**Re: Monterey Bay Shore Ecoresort Project
A-3-SNC-98-114-EDD (Security National Guaranty, Inc.)**

Hearing: Dispute Resolution (Condition Compliance), May 15, 2015

EXHIBIT 13- DUNE VIEW LINE

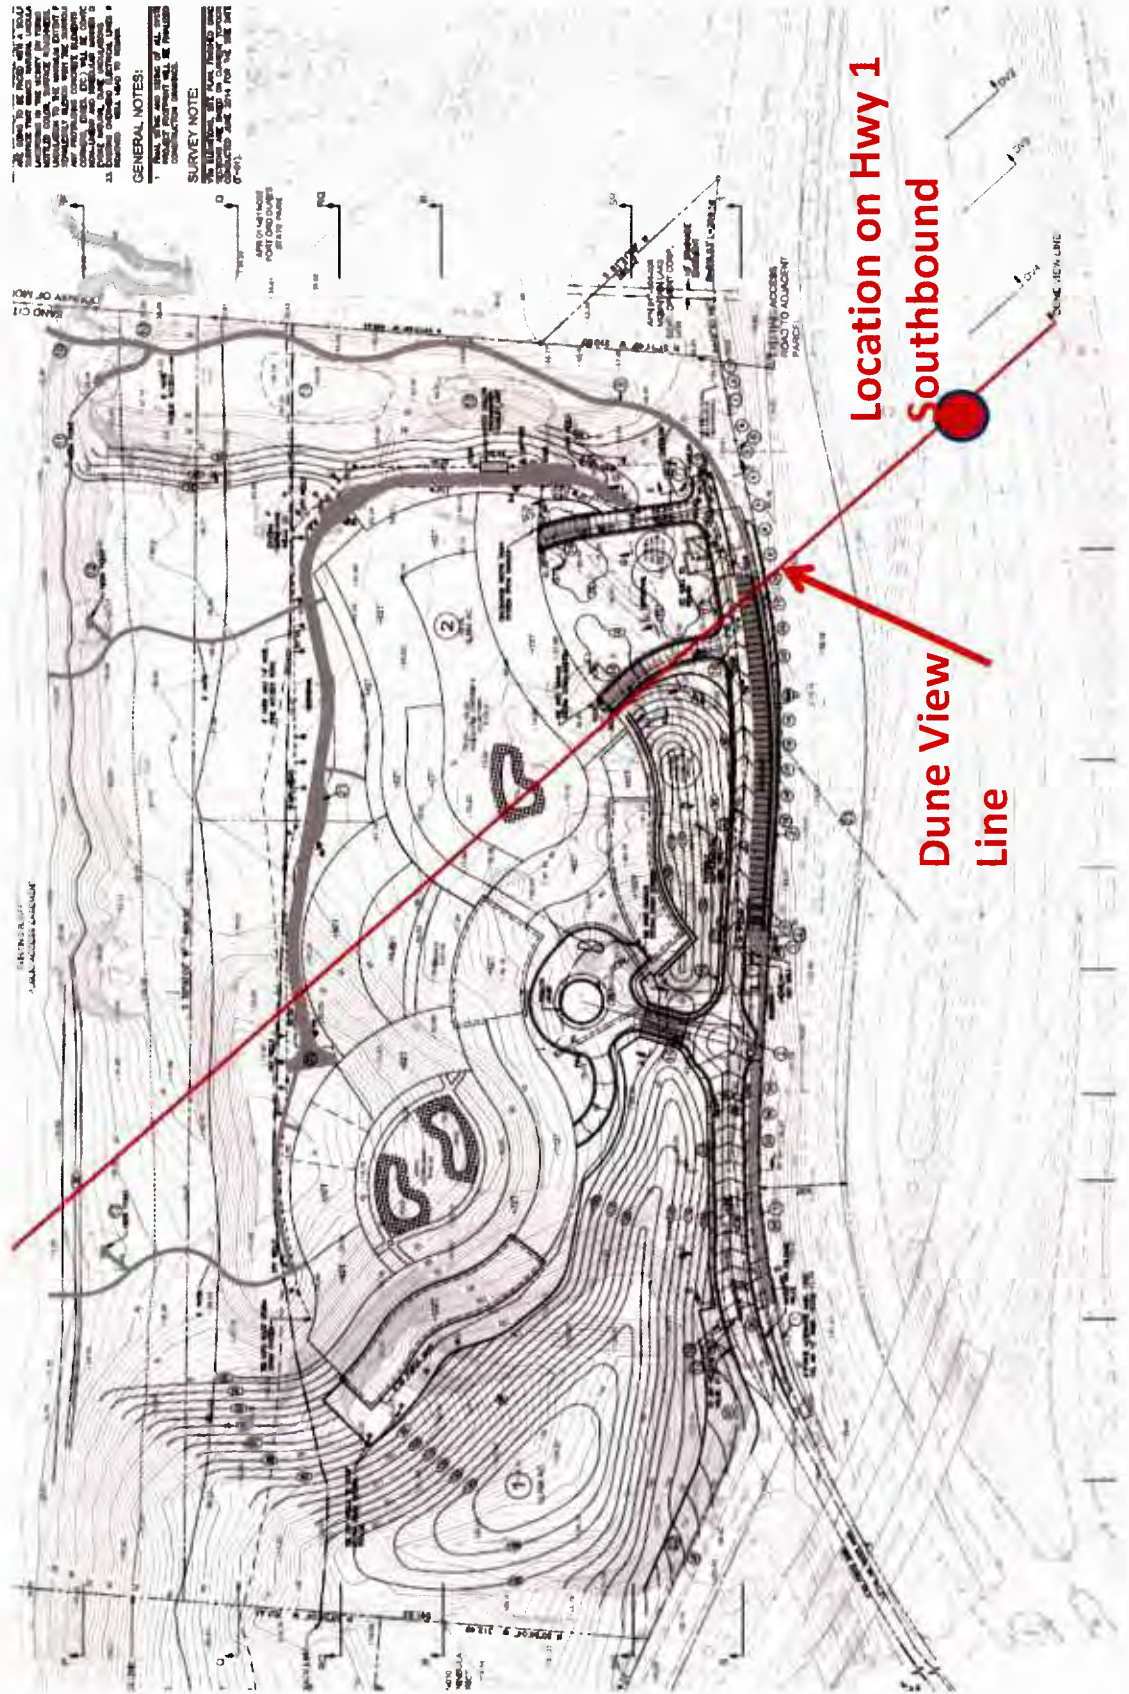
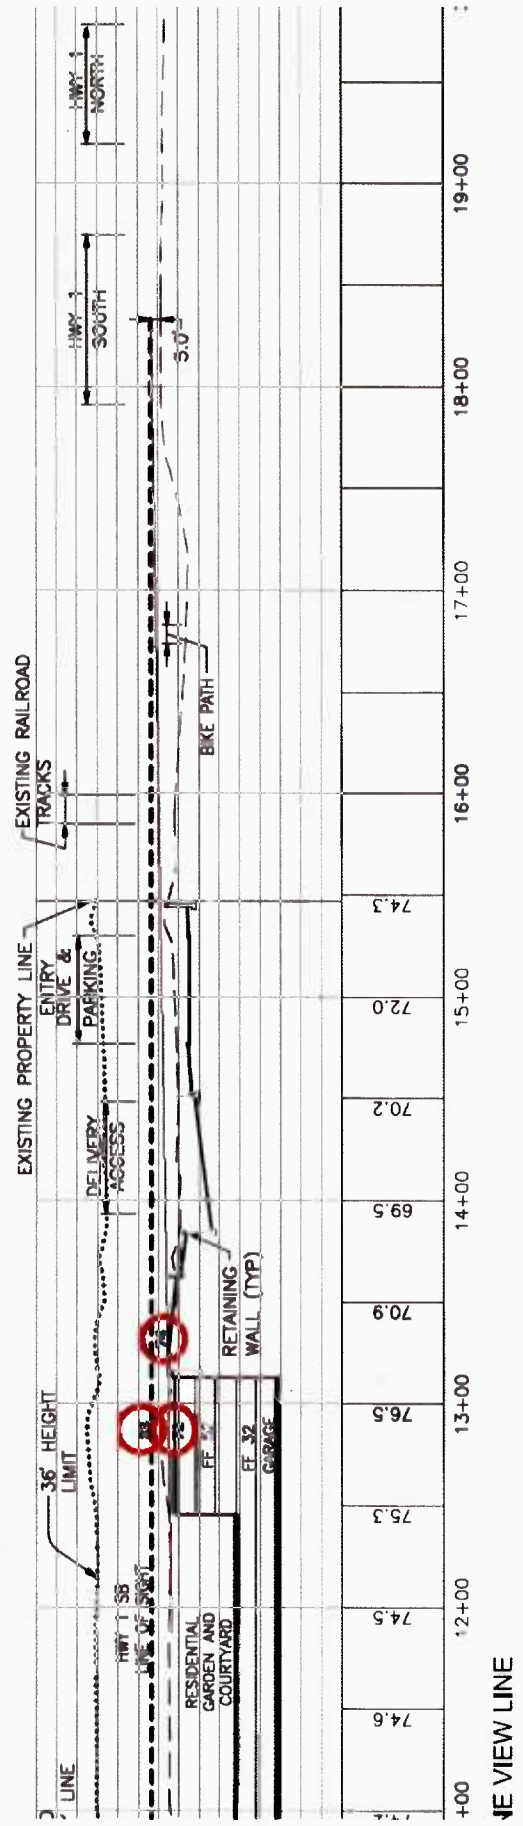
The Staff Report (at page 9) additionally states that the plans show development north of the dune view line that is taller than existing grade and that development "must be below existing grade or hidden by dunes that can be no higher than three feet above existing grade." This is fundamentally and legally wrong. The building heights were, as previously explained, fixed in the Settlement Agreement and the VTM attached to it which accompany this letter as **Exhibit 12**, and the introductory paragraph of Special Condition 1 which approved the VTM, and the Revised Plans show the buildings exactly at the heights approved. Nothing in the conditions states that building must be below existing grade, and the 3' limit does not apply to the buildings at all, but rather applies only to the dunes for "replicated dune landscaping."

The Staff Report (at page 9) asserts that dune manipulation in aid of screening structures "will lead to its own additional view blockage." This is, frankly, nonsense. Special Condition 1(a) permits "dune field manipulation north of the extended dune for screening purposes" and Special Condition 1(b) provides that the buildings be sited and designed so that they are blocked by existing and/or "modified dune features." Clearly, dune screening of structures is expressly permitted, but nothing in the Revised Plans submitted to comply with Special Condition 1 creates any "additional view blockage," and the Staff Report does not and cannot identify any such instance. In fact, in a number of instances the blue water view is enhanced.

One further point bears emphasis. The Auto-Cad views were requested by staff, but despite the "reality" that staff seems to want, it told SNG to remove anything between the Highway One and the development area. So, what the Commission sees in the Auto-Cad view is not what one sees, in reality. It is what one sees only if the area is swept clean of any view obstructions in the foreground. To give the Commission a better sense of reality, SNG provides a "Z" cross-section and cross-section of the Dune View Line, each followed by the Auto-Cad view and then the view with the existing Cypress trees, vegetation, light standards, freeway signage and railroad tracks in the foreground off the property. These accompany this letter collectively as **Exhibit 13**.

EXHIBIT 14
CONSERVATION EASEMENT AREA IN DUNE RESTORATION PLAN

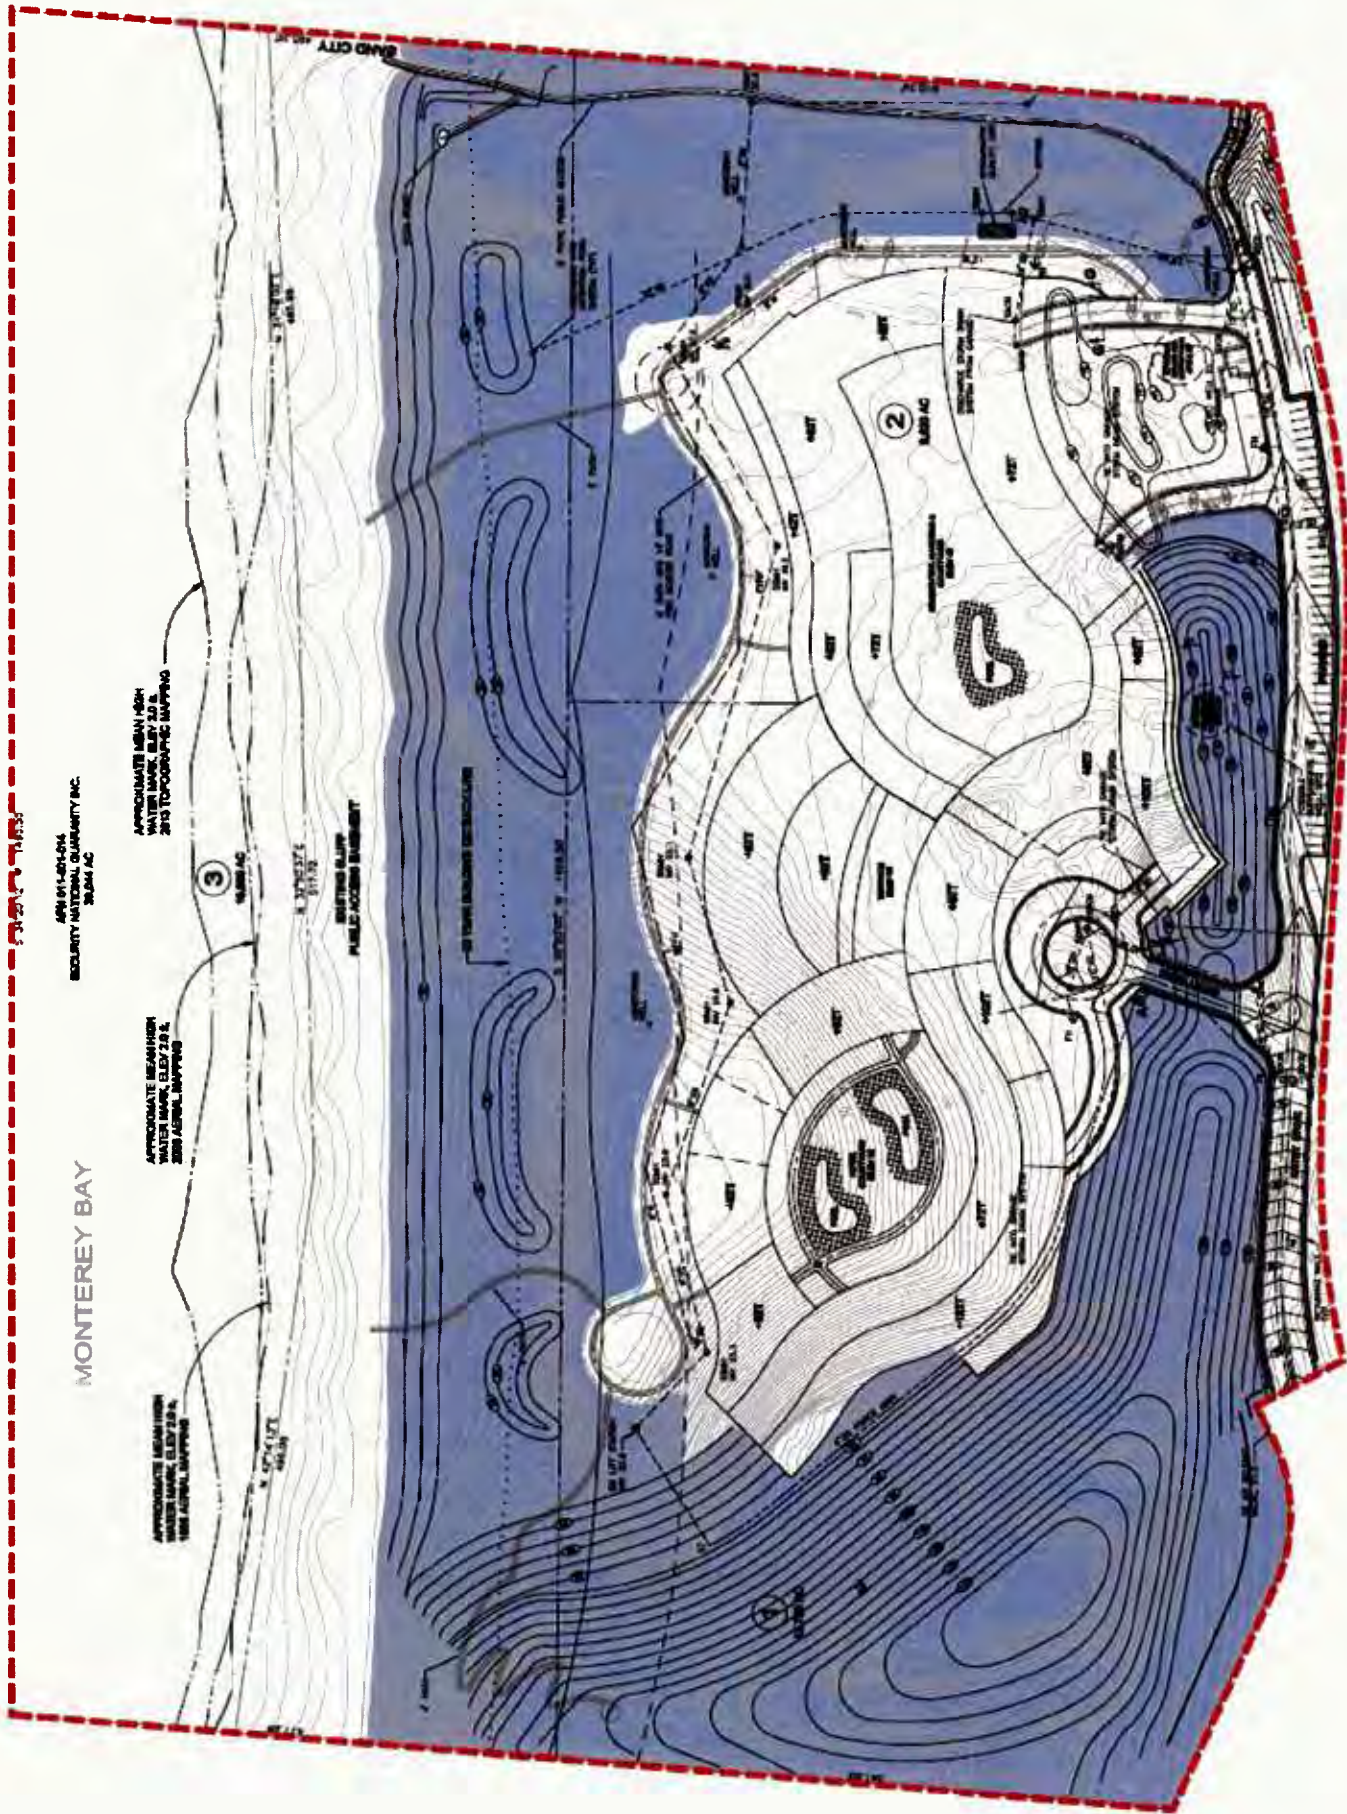
The referenced October 2013 Habitat Protection Plan (HPP) provided a dune conservation easement (accompanying this letter as **Exhibit 14**) which specifically described the dune conservation area outside of the development areas. The development area included not merely the buildings themselves but also the entry road, the parking area, the entrance driveways to the Project, and the areas next to the buildings (but located inland for the fire access road) necessary to accommodate the fire road and essential project stormwater infrastructure (including bio-filtration areas, engineered stormwater filters, piping, and dry well pits).

Habitat Protection Plan and referred to in both Special Conditions. From that, the Staff Report (on page 15) improperly asserts that the Project's essential stormwater infrastructure (including bio-filtration areas, engineered stormwater filters, piping, and dry well pits) are not permitted because they are located in staff's broad-brush conservation area shown "generally" on Exhibit 11a.

Second, nothing in the April 2014 Staff Report or staff's presentation at the April 2014 hearing supports the notion that the "general" depiction on Exhibit 11a was somehow intended to trump the specific depiction of the conservation easement in the Dune Restoration Plan.

That said, SNG merely wishes to complete condition compliance and ensure that the verbiage in the OTDs is correct and the graphics attached to the document are accurate. As explained in #8 above, the conservation easement graphic attached to staff’s revised OTD for the conservation easement is not accurate.
